# UNITED STATES PATENT AND TRADEMARK OFFICE

APPLICATION NO.	FILING DATE	FIRST NAMED INVENTOR	ATTORNEY DOCKET NO.	CONFIRMATION NO.
10/707,291	12/03/2003	David W. Pratt	1053.30	1290
21901	7590	02/16/2006	EXAMINER	
SMITH & HOPEN PA 15950 BAY VISTA DRIVE SUITE 220 CLEARWATER, FL 33760			CHIN, PAUL T	
			ART UNIT	PAPER NUMBER
			3652

<b>Office Action Summary</b>	<b>Application No.</b>		<b>Applicant(s)</b>	
	10/707,291		PRATT, DAVID W.	
	<b>Examiner</b>		<b>Art Unit</b>	
	PAUL T. CHIN		3652

## EXHIBIT A

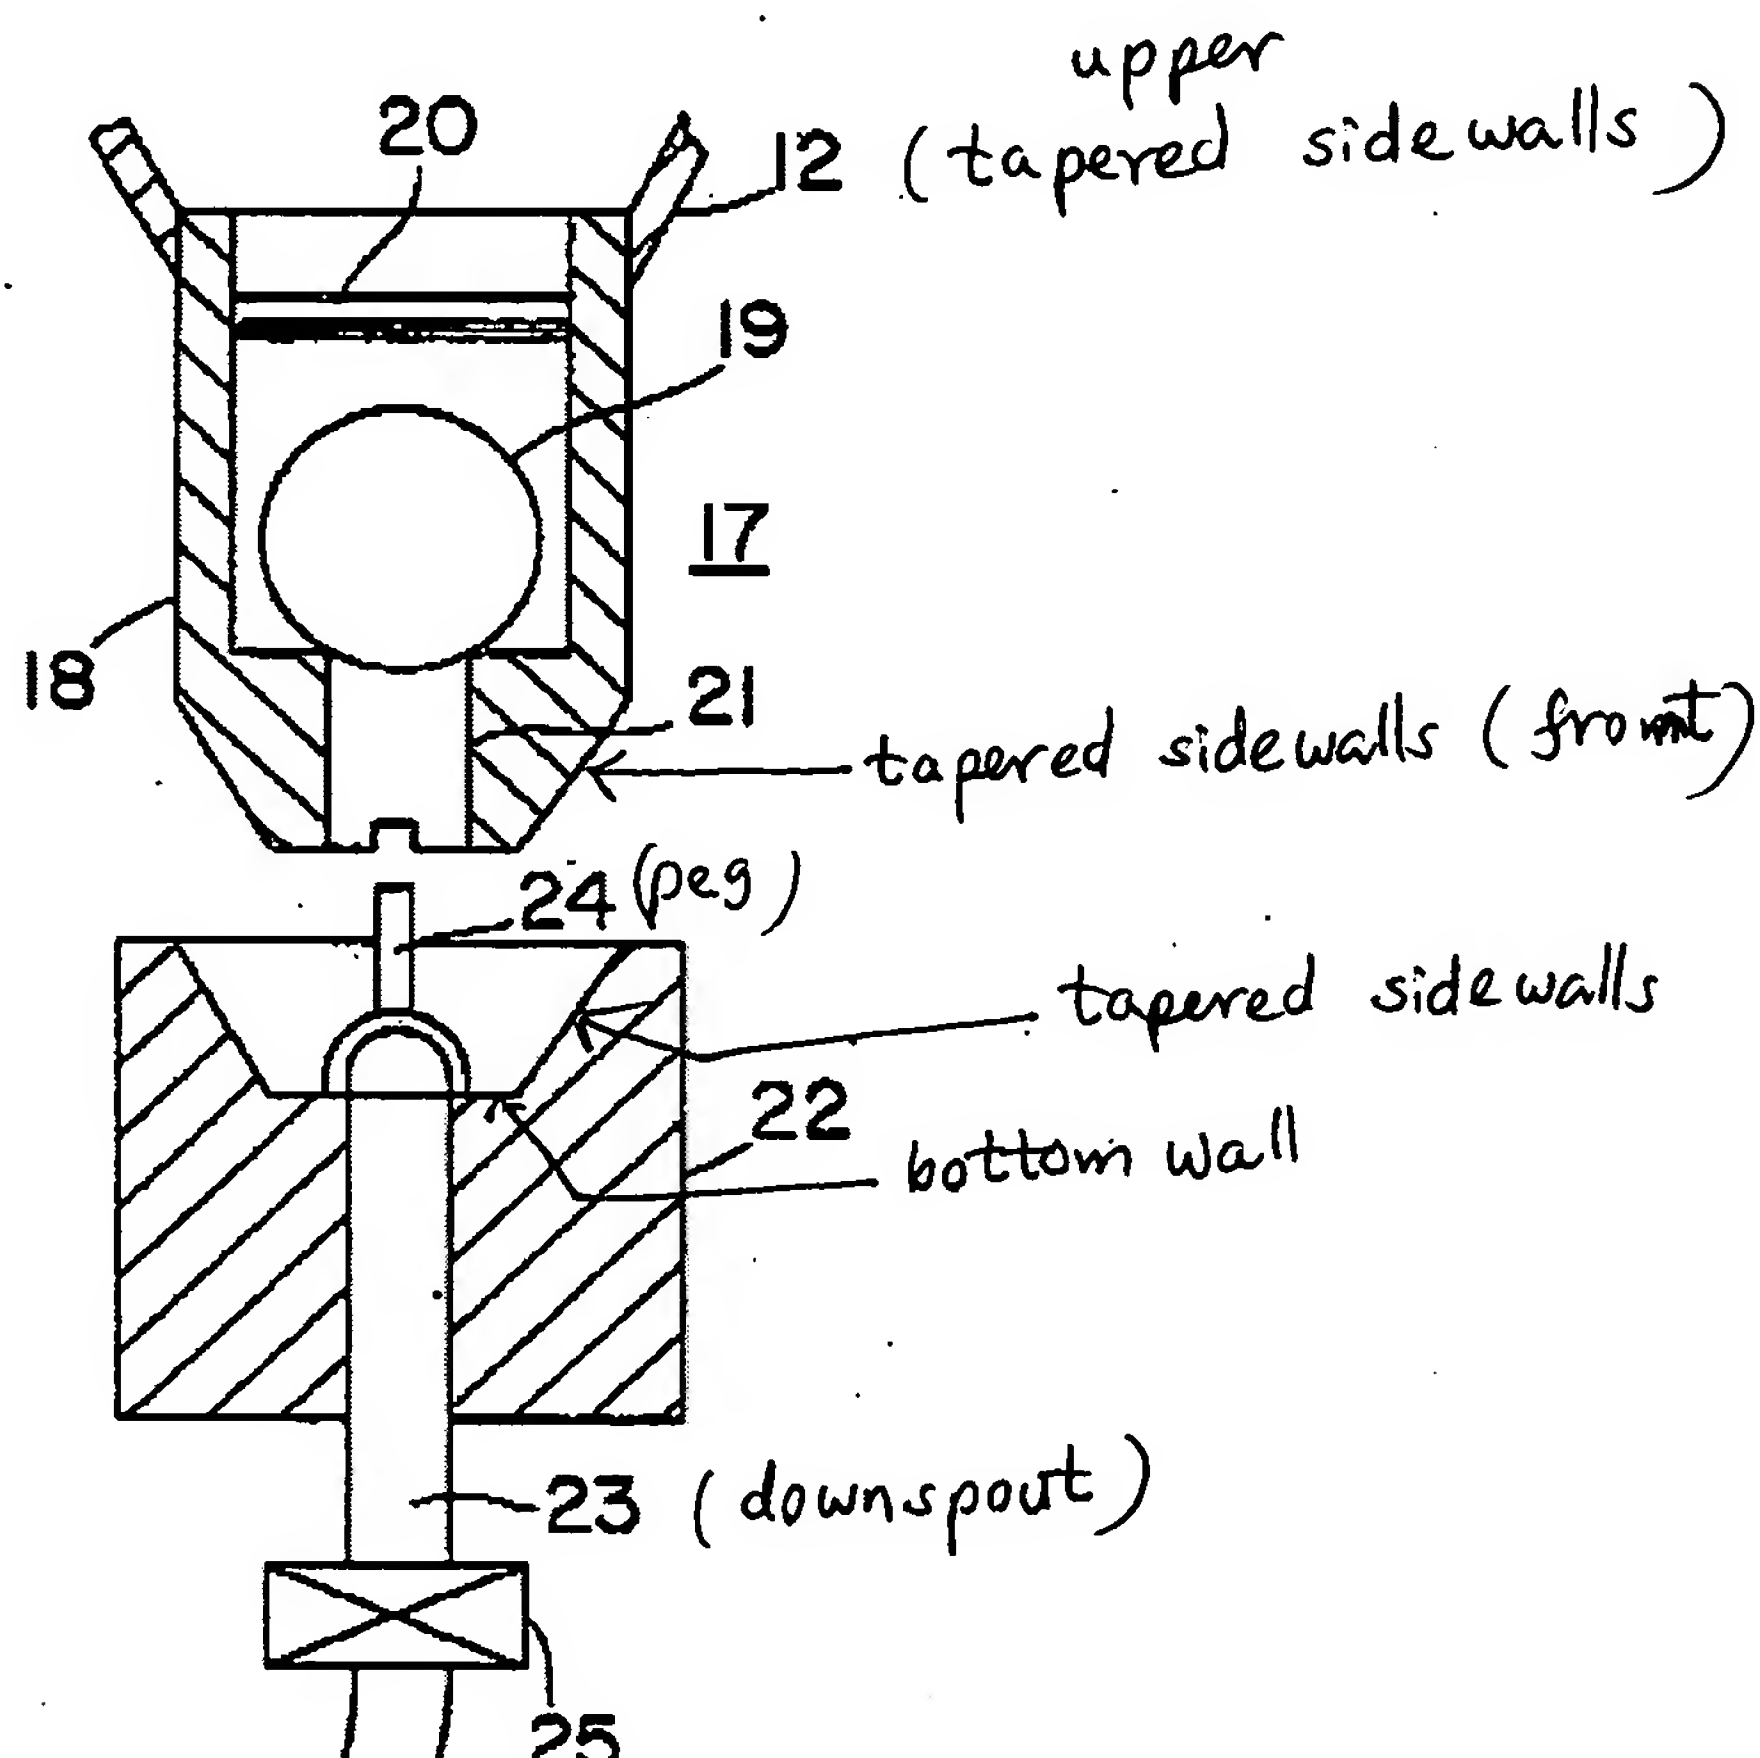
mounted in upstanding relation to said bottom wall, said peg being positioned adjacent said aperture. Note that Hunkin et al. (4,590,810) shows a valve housing having upper tapered walls (12) and lower tapered walls as shown in figure 1.

Exhibit A shows a bottom emptying device having a bottom wall and tapered side walls mounted about the periphery of the bottom wall wherein the bottom wall further having an aperture and a peg (24) mounted in upstanding relation to the bottom wall, and a downspout (23) depending from the bottom wall and being positioned substantially adjacent to the aperture. The downspout (23) has an inner bore or a lumen to allow the fluid flow from the downspout to the desired container.
